# Sand Canyon Plaza Mixed-Use Project Final Environmental Impact Report

August 2017

## 1. Introduction

**Figure 3-5 Sand Canyon Plaza Mixed-Use Project Planning Areas**

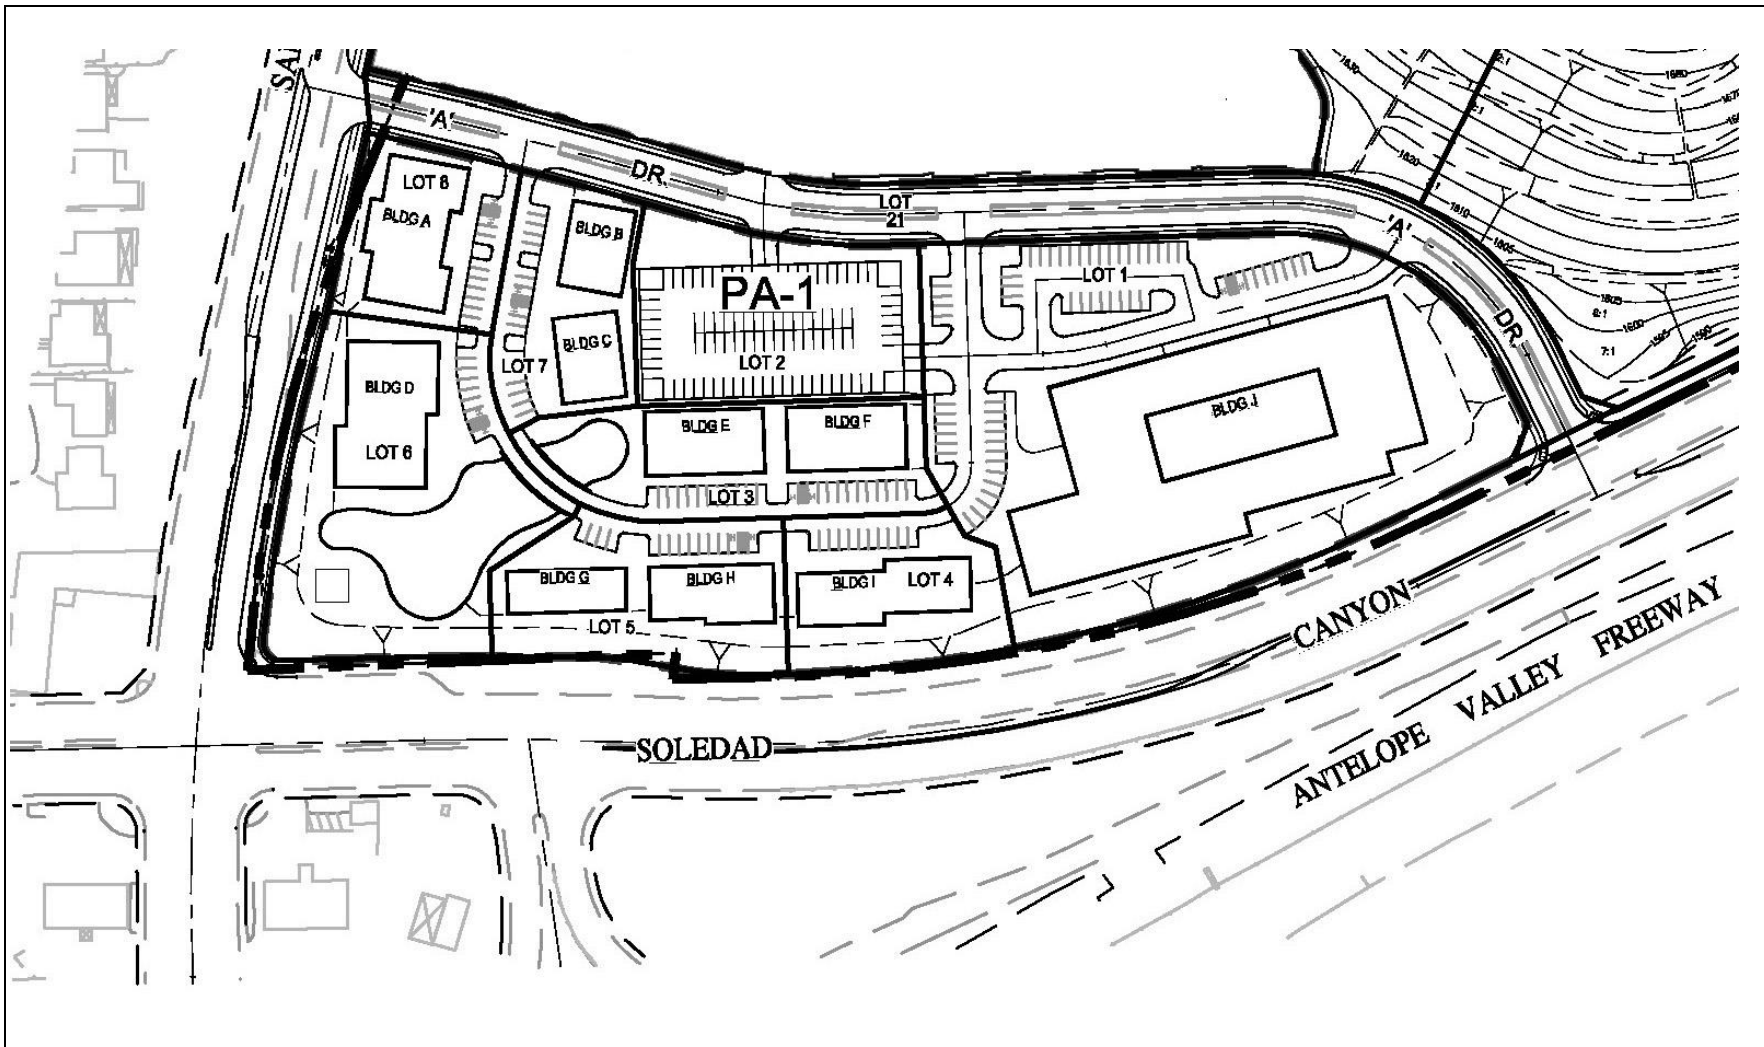
The approximately 87-acre Project site is divided into five Planning Areas. **Figure 3-5** depicts each Planning Area in relationship to the entire Project site. Details further describing the Planning Areas are provided below.
